LAKESIDE COMMERCIAL PARK FIRST ADDITION, RESUBDIVISION OF THE NORTH PART OF LOT 18

APPLICATION NUMBER 3 DATE January 19, 2023
 APPLICANT Lakeside Commercial Park First Addition, Resubdivision of the North Part of Lot 18
 REQUEST Subdivision

DETAIL SITE PLAN

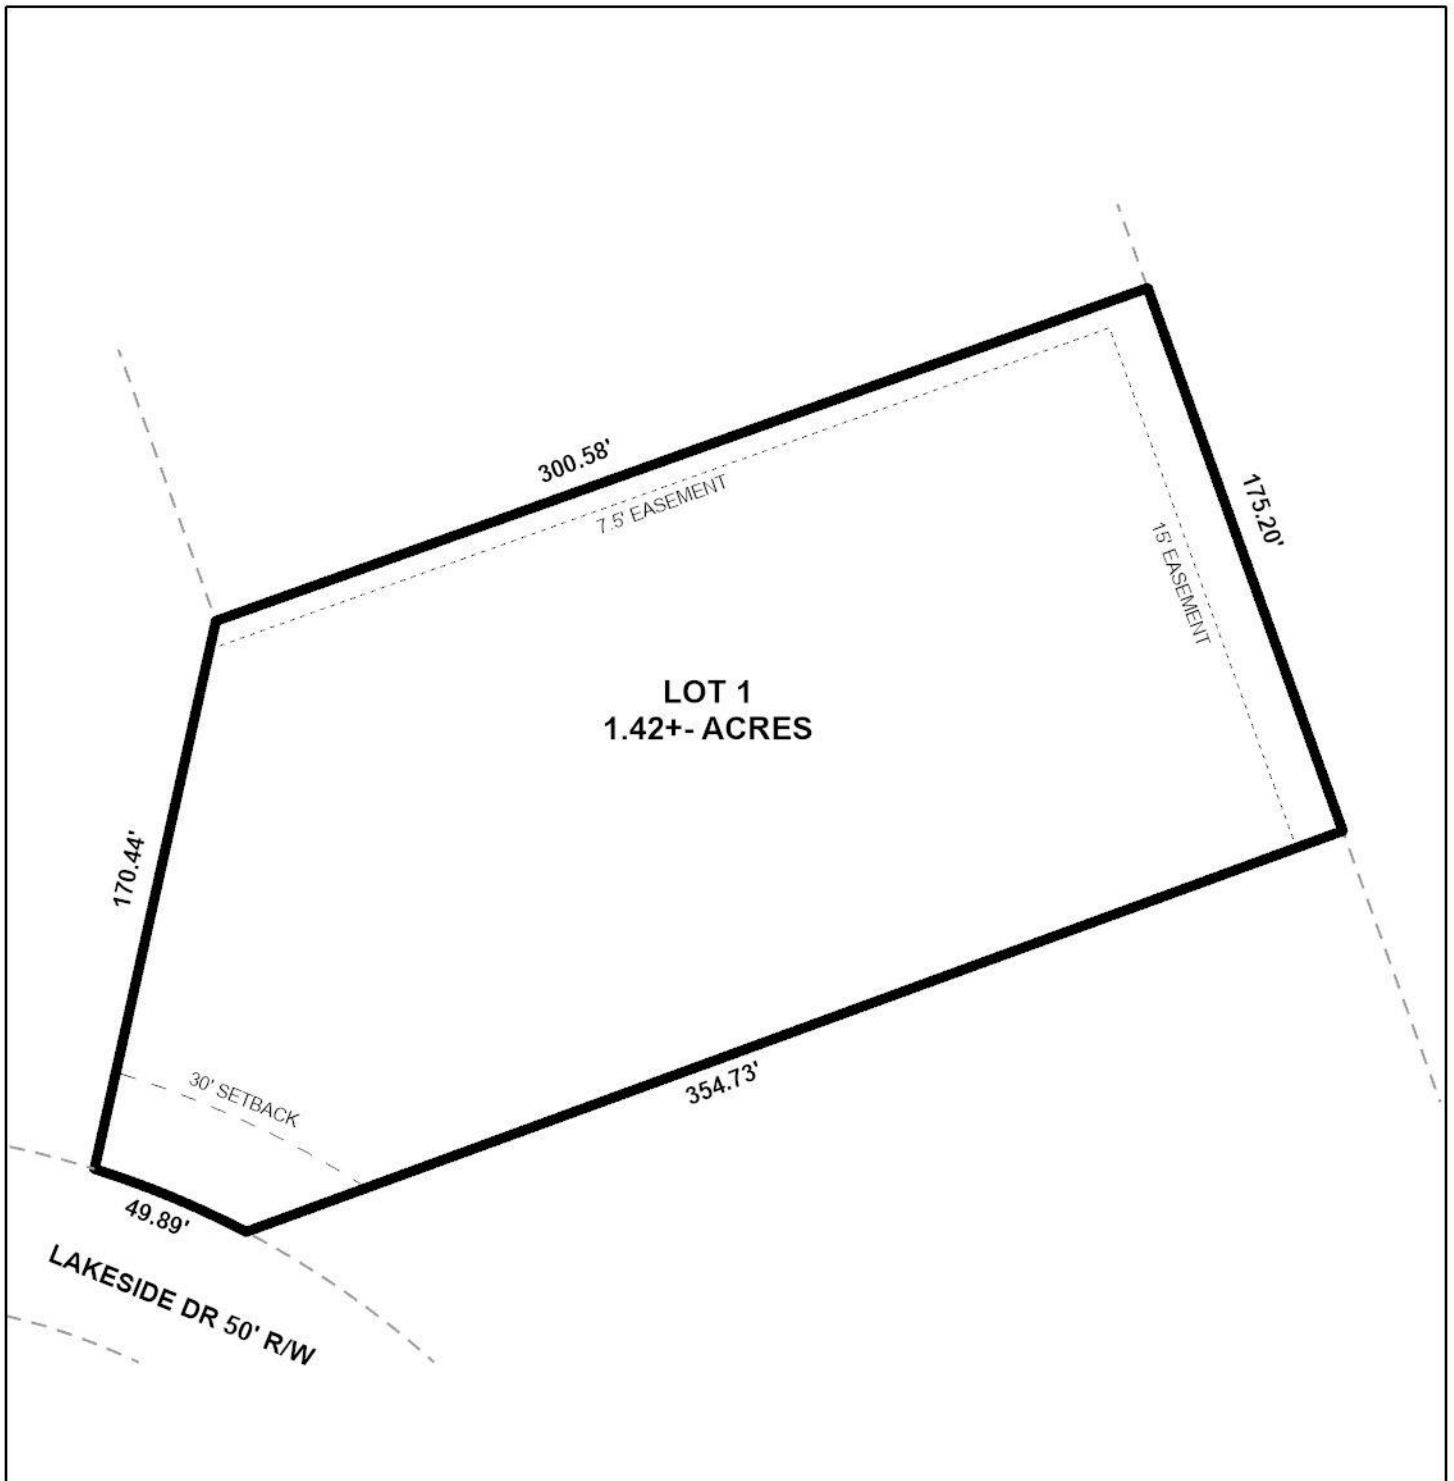
- A. Provide all of the required information on the SUBDIVISION PLAT (i.e. signature blocks, signatures, certification statements, written legal description, required notes, legend, scale, bearings and distances) that is required by the current Alabama State Board of Licensure for Professional Engineers and Land Surveyors.

- B. Show and label the POC and the POB.
- C. Clarify the bearing and distances shown on the PLAT and label them as “record”, “actual”, “calculated”, “deed”, etc.

- D. Revise NOTE #13 from “All proposed...” to “All existing or proposed...”.
- E. Add a note to the SUBDIVISION PLAT stating that as shown on the 1984 aerial photo (FLIGHT 24 - #81) LOT 1 will receive the historical credit of existing (1984) impervious area towards stormwater detention requirement per Mobile City Code, Chapter 17, Storm Water Management and Flood Control). The lots will be allowed to add the following amount of impervious area before storm water detention is required: LOT 1 – 33,000 sf.

The site has frontage on Lakeside Drive, a minor street with curb-and-gutter, which has an existing compliant 50-foot right-of-way; therefore, no additional dedication should be required. As on the preliminary plat, the right-of-way width of Lakeside Drive should be retained on the Final Plat, if approved.

The preliminary plat submitted depicts a 30-foot minimum building setback line along Lakeside Drive, which should be retained on the Final Plat, if approved; or, a 25-foot minimum building setback line may be illustrated where the lot is at least 60 feet in width, per Section V.D.9 of the Subdivision Regulations.

Based on the preliminary plat, the proposed lot exceeds the minimum size requirements of the Subdivision Regulations for lots served by public water and sanitary sewer. If approved, the lot size in square feet and acres should be retained on the Final Plat.

The preliminary plat depicts existing drainage and utility easements. If approved, a note should be placed on the Final Plat stating that no structure is allowed in any easement without the approval of the easement holder.

- 1) retention of the right-of-way width of Lakeside Drive;
- 2) retention of at least the 25-foot minimum building setback line along Lakeside Drive, per Section V.D.9.;

- 3) placement of a note on the Final Plat stating that no structure is allowed in any easement without the approval of the easement holder;
- 4) compliance with the Engineering comments: (*FINAL PLAT COMMENTS (should be addressed prior to submitting the FINAL PLAT for review and/or signature by the City Engineer): A. Provide all of the required information on the SUBDIVISION PLAT (i.e. signature blocks, signatures, certification statements, written legal description, required notes, legend, scale, bearings and distances) that is required by the current Alabama State Board of Licensure for Professional Engineers and Land Surveyors. B. Show and label the POC and the POB. C. Clarify the bearing and distances shown on the PLAT and label them as "record", "actual", "calculated", "deed", etc. D. Revise NOTE #13 from "All proposed..." to "All existing or proposed..." E. Add a note to the SUBDIVISION PLAT stating that as shown on the 1984 aerial photo (FLIGHT 24 - #81) LOT 1 will receive the historical credit of existing (1984) impervious area towards stormwater detention requirement per Mobile City Code, Chapter 17, Storm Water Management and Flood Control). The lots will be allowed to add the following amount of impervious area before storm water detention is required: LOT 1 – 33,000 sf. F. Email a pdf copy of the FINAL SUBDIVISION PLAT and LETTER OF DECISION to the Permitting Engineering Dept. for review at land.disturbance@cityofmobile.org prior to obtaining any signatures. No signatures are required on the drawing.*);
